## AGENDA

**Joint Town/University Committee**  
**Development Plan Modification: Cobb Deck and Northeast Chiller Plant**  
**Center for Dramatic Arts**  
**July 31, 2003**

**SUMMARY OF A JOINT TOWN-UNIVERSITY  
MEETING ON UNC DEVELOPMENT PLANS  
THURSDAY, JULY 31, 2003 AT 10:00 A.M.  
KENAN THEATRE, CENTER FOR DRAMATIC ARTS, UNC CAMPUS**

**References to Information in UNC Utility Study**  
**"Energy Systems – Infrastructure Improvements" - December 2, 2002**

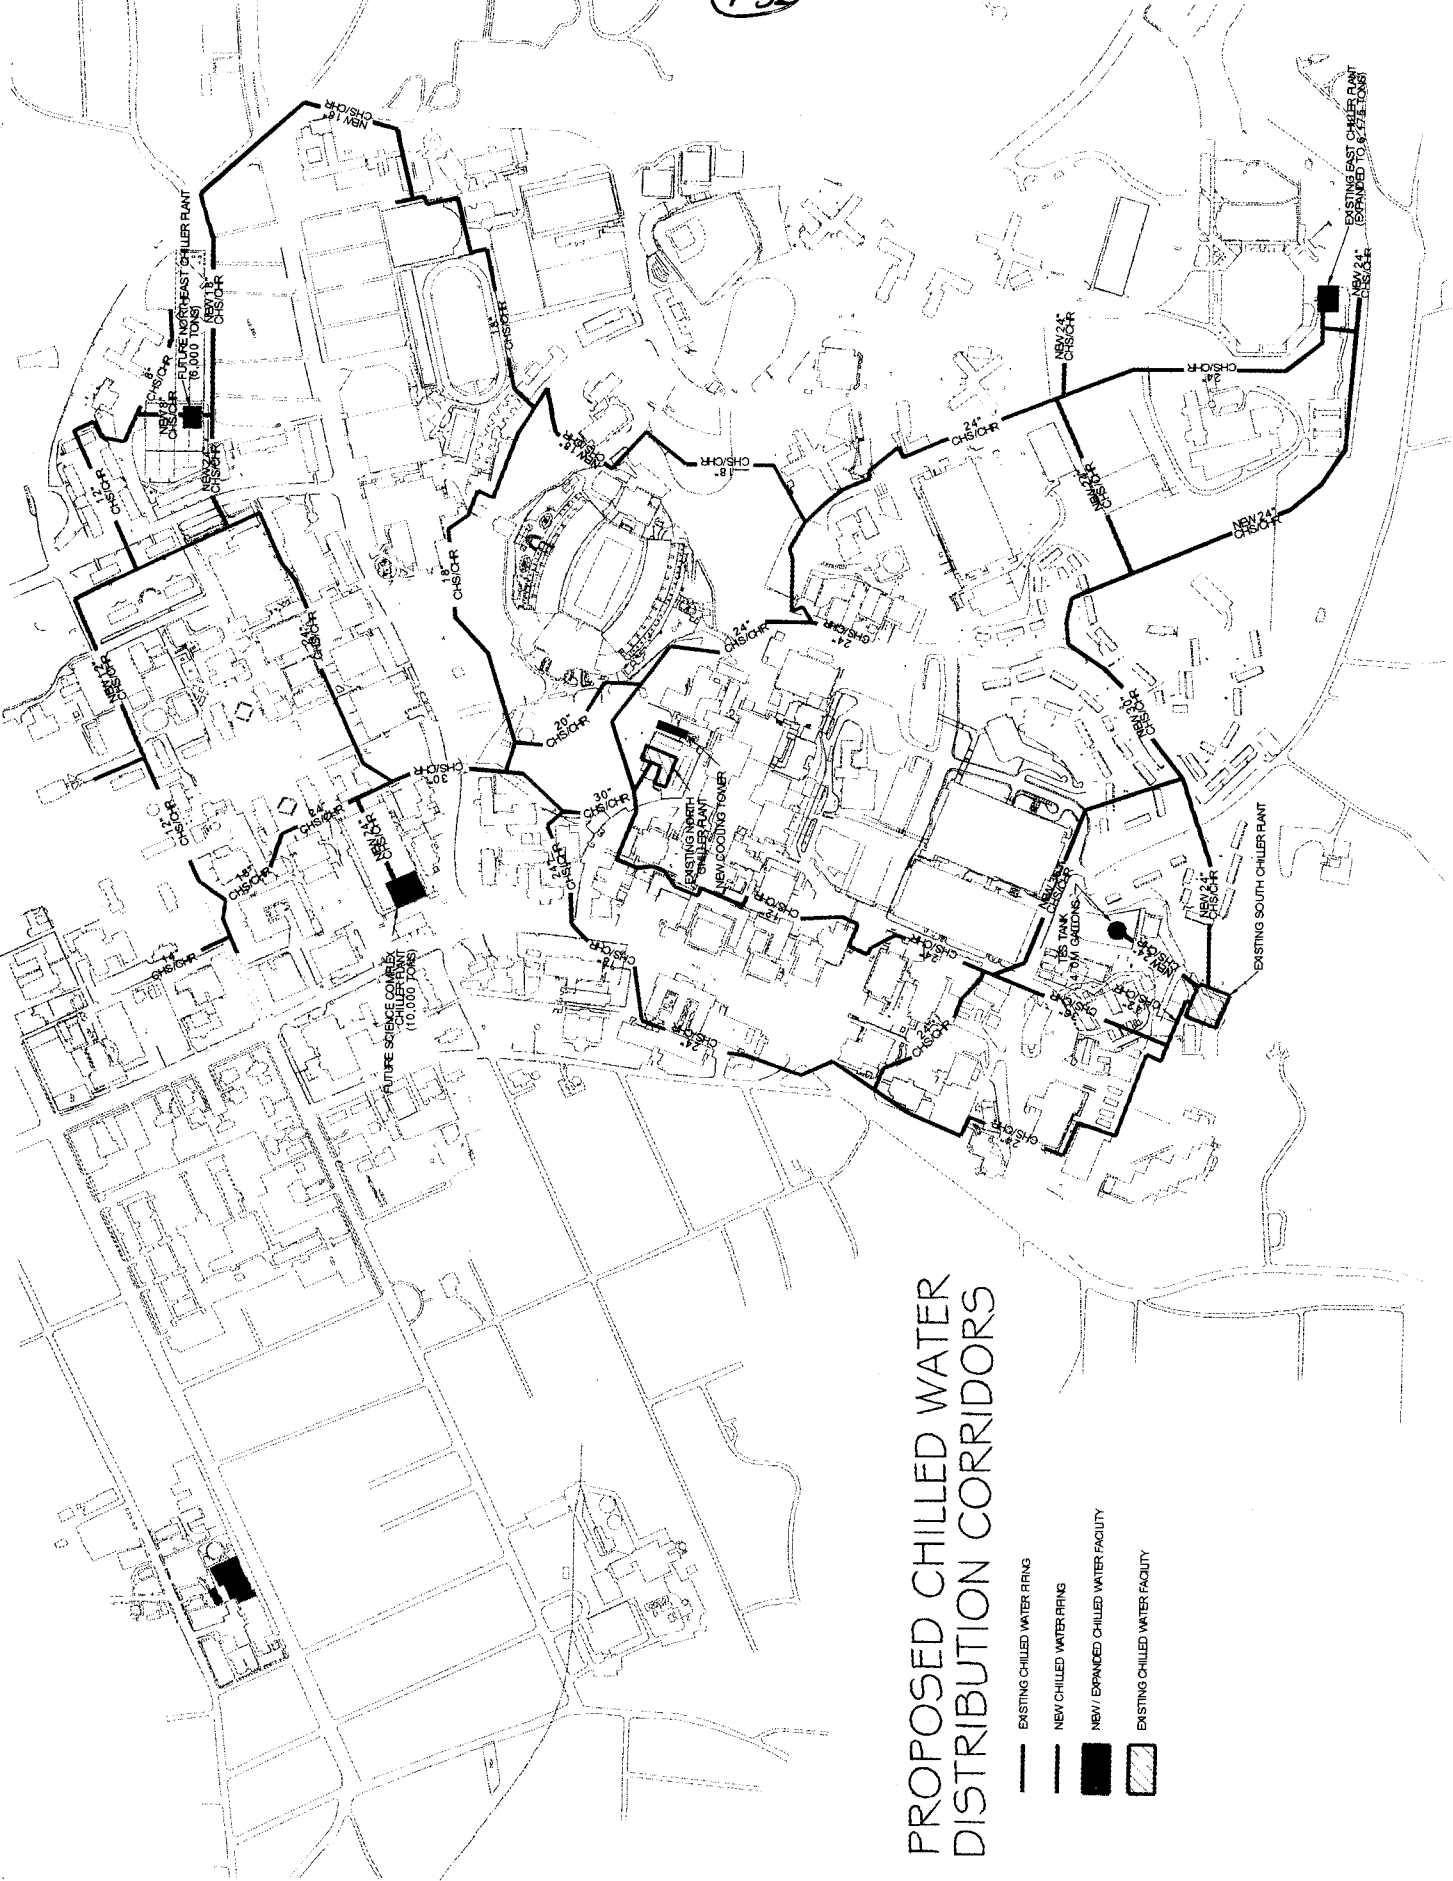
Using material previously provided by the University, Council Member Strom noted that the figures on pages VI and VII indicate that the current capacity of chilled water is 33,000 tons, with a maximum capacity of 39,000. Referring to page 4.2, he said that at the end of ten years a capacity of 40,000 tons was needed. On page 4.4, Council Member Strom continued, the materials note that phased installation of additional capacity would result in a gain of 2,600 tons through efficiency, a gain of 2,500 tons through east plant expansion, and a gain of 4,000 through Thermal Energy Storage (TES). Council Member Strom said this leads him to conclude that with a current 33,000 ton capacity plus the additional 9,000 tons without adding the Cobb chiller, an additional chiller plant is not critical.

Referring to the peak chart on page 3.6 of the previous materials, Mr. DuBose noted that the University experiences peak demand in July. He said that it is difficult to phase requirements for upgrades, and noted that TES is not capacity.
